WYNNFIELD SUBDIVISION,

UNIT 5

Engineering Comments: The following comments should be addressed prior to submitting the FINAL PLAT for acceptance and signature by the City Engineer:

DETAIL SITE PLAN

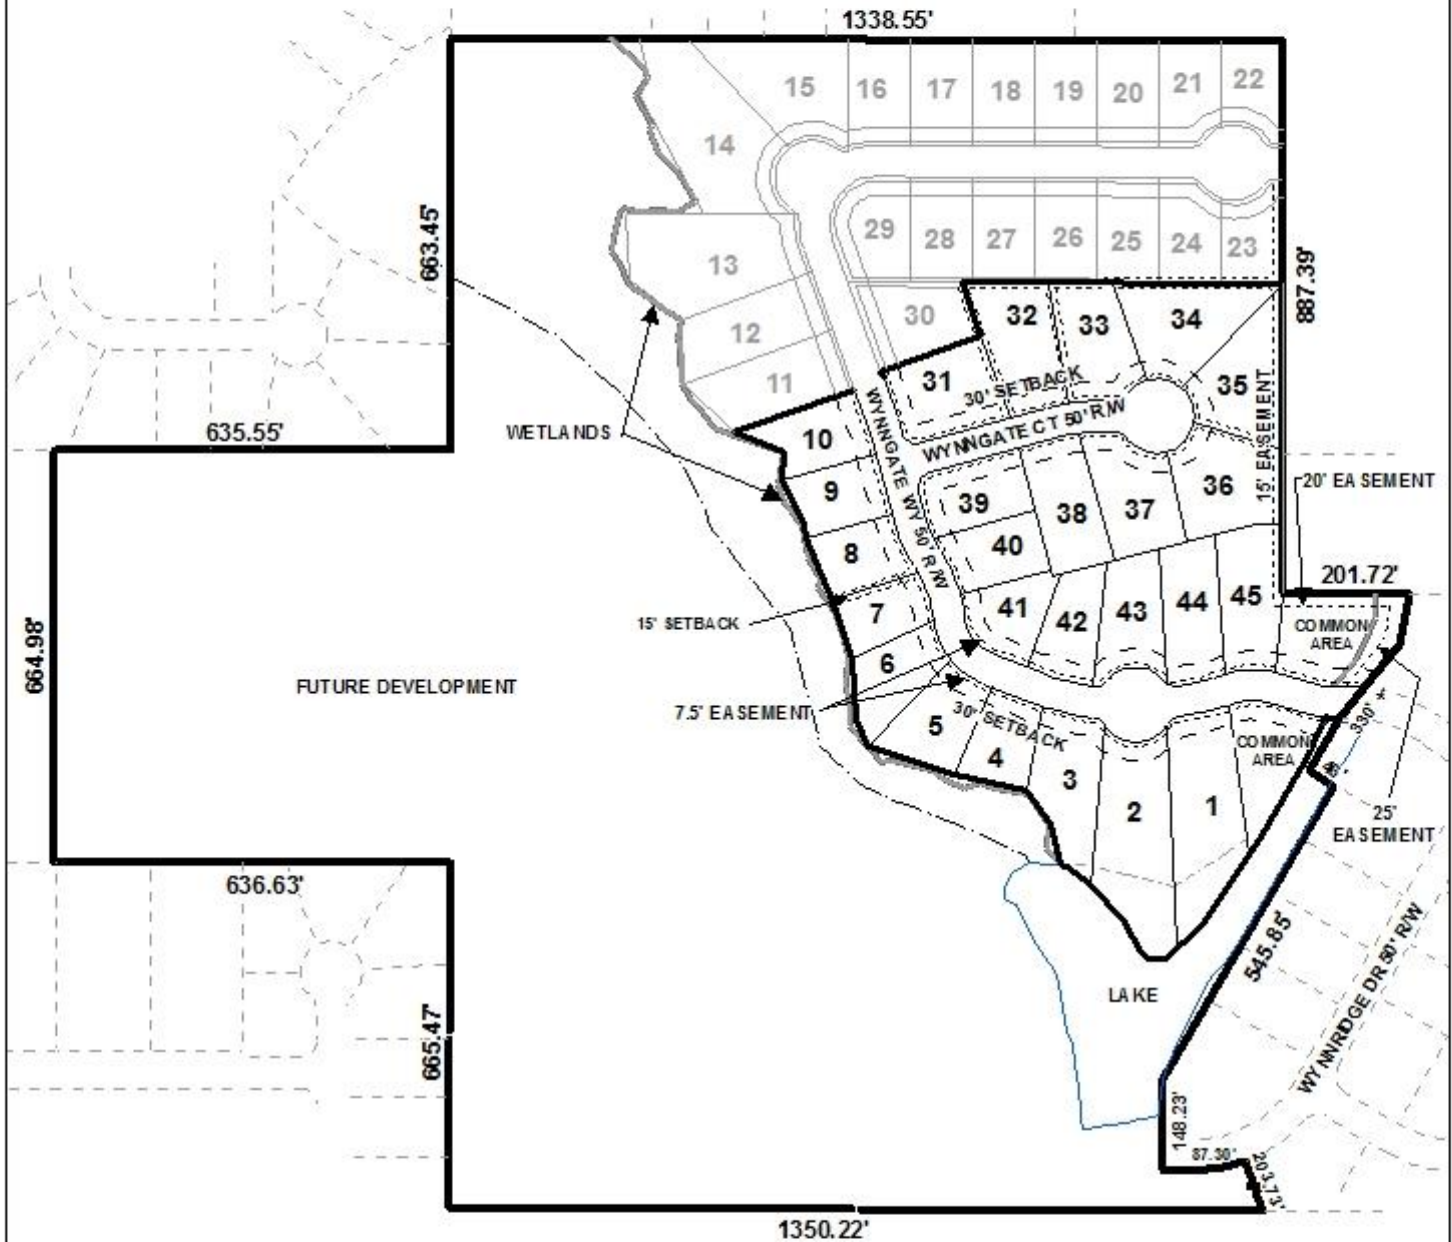
- D. Add street names to the vicinity map.
- E. Label the area enclosed by the curves #14 – 17 (located between Lots 2 and 43). Is it Common Area?
- F. Provide an updated Plat for review after revising the centerline of Wynngate Way to meet the requirements the Subdivision Regulations.

- G. Review and revise the written legal description to include a written bearing and distance near Lot 6.
- H. Correct the Subdivision Name from “Wynnfiend” to “Wynnfield”.

Traffic Engineering Comments: Per Section V.B.12 of the Subdivision Regulations, the alignment of Wynn gate Way from Curve 4 to Curve 6 should be modified to eliminate the series of reverse curves with no 100 foot tangent in between. Driveway number, size, location and design to be approved by Traffic Engineering and conform to AASHTO standards.

It should be pointed out that the proposed subdivision site abuts two adjacent landlocked parcels to the east and west of the site. The preliminary plat depicts a proposed street stub to the east adjacent to the proposed Lots 22 and 23; however, it appears that the landlocked parcel abuts property to the south and southeast within the Isle of Palms Subdivision (which is accessed by private streets) that is under ownership by the same family or corporate entity, thus access to the parcels should not be required for the application at hand. The plat should be revised to depict only a cul-de-sac at the eastern terminus of the proposed street.

It should be pointed out that the subdivision name on the plat reads "Wynnfiend" and should be revised on the revised plat to read "Wynnfield."

- 4) Revision of the plat to depict only a cul-de-sac at the eastern terminus of Wynngate Way, adjacent to the proposed Lots 22 and 23;
- 5) Revision of the Subdivision name on the plat from "Wynnfiend" to "Wynnfield";

As currently proposed, the revised plat depicts a cul-de-sac at the eastern terminus of the proposed Wynngate Way adjacent to the proposed lots 20-25; however, the plat still does not depict connectivity to the southern terminus of Widgeon Drive of the adjacent subdivision to the north. The provision of a street stub is also not illustrated to the south and west of the site to ensure connectivity with the Raleigh Subdivision and the landlocked parcel to the west. Furthermore, the applicant has still not submitted an overall site layout for the area reserved for future development, in compliance with Sections I.B.1. and I.C.2. of the Subdivision Regulations regarding orderly development and health and safety. As proposed, all lots would be served by one access point and would not appear to comply with the International Fire Code requirements, as adopted by the City of Mobile.
